June 12, 2007

**RE: ADDENDUM, CONCEPTUAL APPROACH TO REMOVAL ACTION,
WAMPUS MILFORD ASSOCIATES SITE, MILFORD, CONNECTICUT
(HRP #FRA-0348.RA)**

FIGURE 1
PROPOSED EXCAVATION PROFILE,
SWALE REMOVAL ACTION
WMA SITE
MILFORD, CT
HRP# FRA0348.RA
VERTICAL SCALE: 1" = 2'
HORIZONTAL SCALE: 1" = 6'

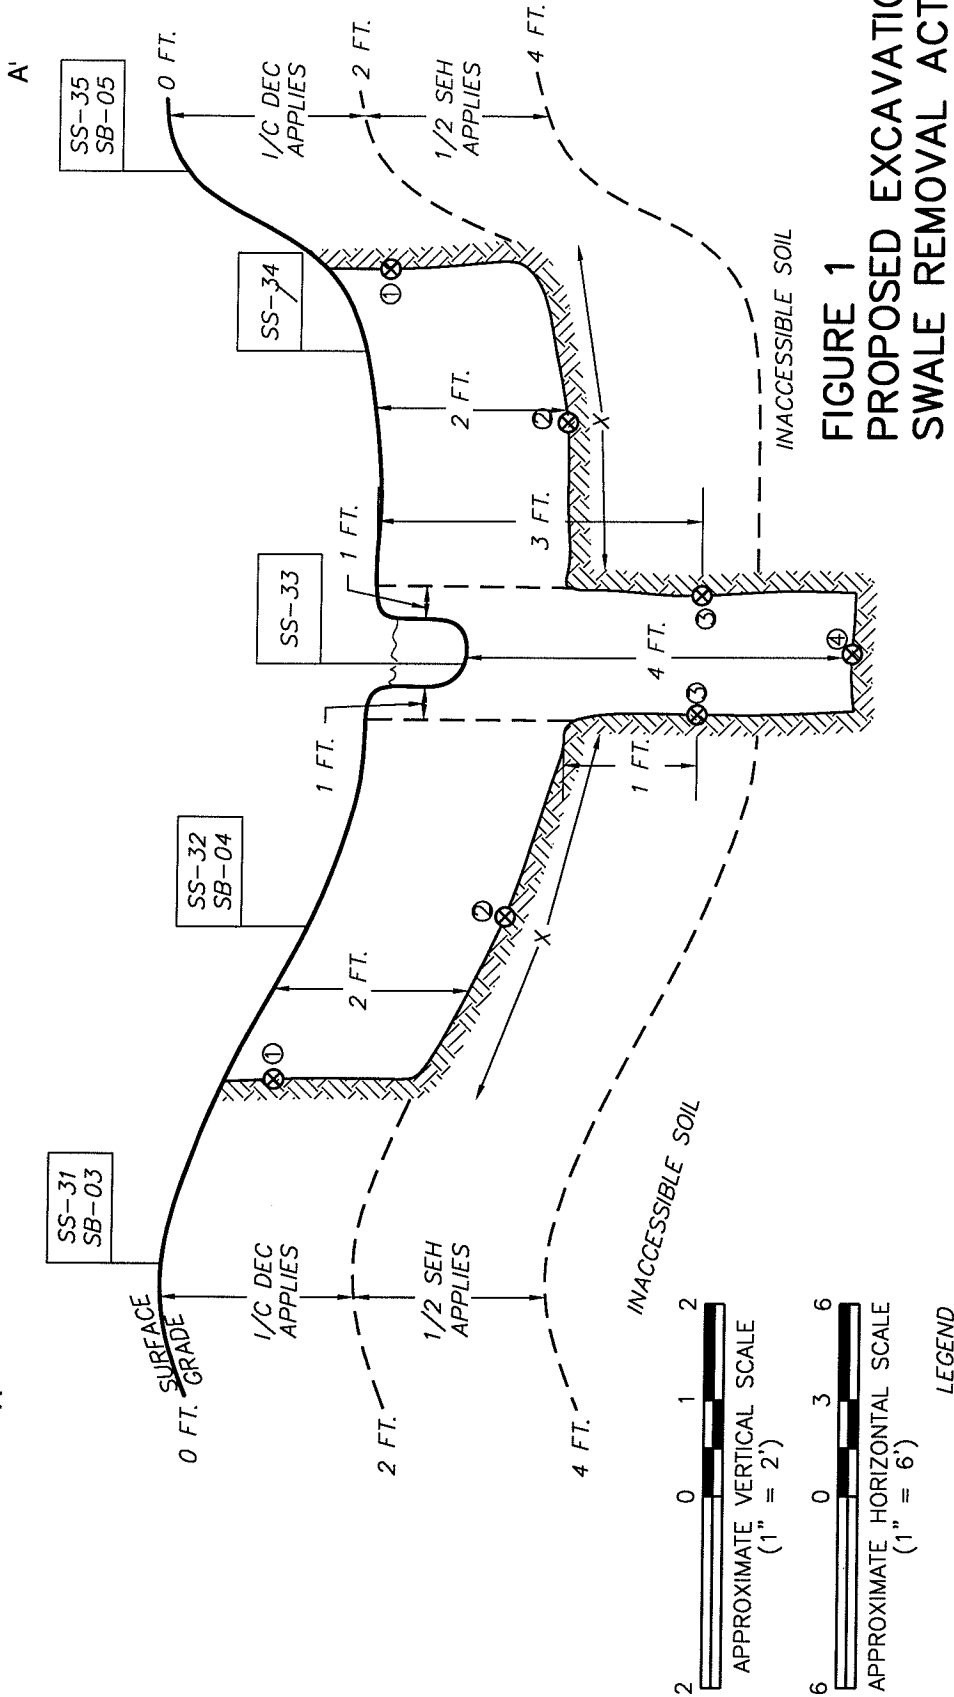
1. The profile of the excavation will be modified as shown on the attached Figure 1, which replaces the schematic profile provided with HRP's May 25, 2007 submittal. Beneath the water bearing channel within the swale drainage, contaminated soil will be excavated to a depth of 4 feet beneath the bottom of the channel. The width of the 4-foot excavation will include the channel, as well as an additional 1-foot on either side of the channel for a minimum width of 4-feet. In addition, immediately adjacent soil (on either side of the 4-foot deep excavation) that exceeds applicable I/C DEC will also be excavated to a depth of 2 feet below grade (as opposed to 6 inches, as previously proposed).

2. In cross section, seven post-excavation confirmatory soil samples will be collected for laboratory analysis from each line of profile as shown on Figure 1. The samples will be tested for the Constituents-of-Concern discussed in the Conceptual Approach to Removal Action (HRP, May 2, 2007) and the Response to EPA Comments (HRP, May 25, 2007). The longitudinal spacing between each cross-sectional line of profile will be 20 feet, measured along the axis of the swale.
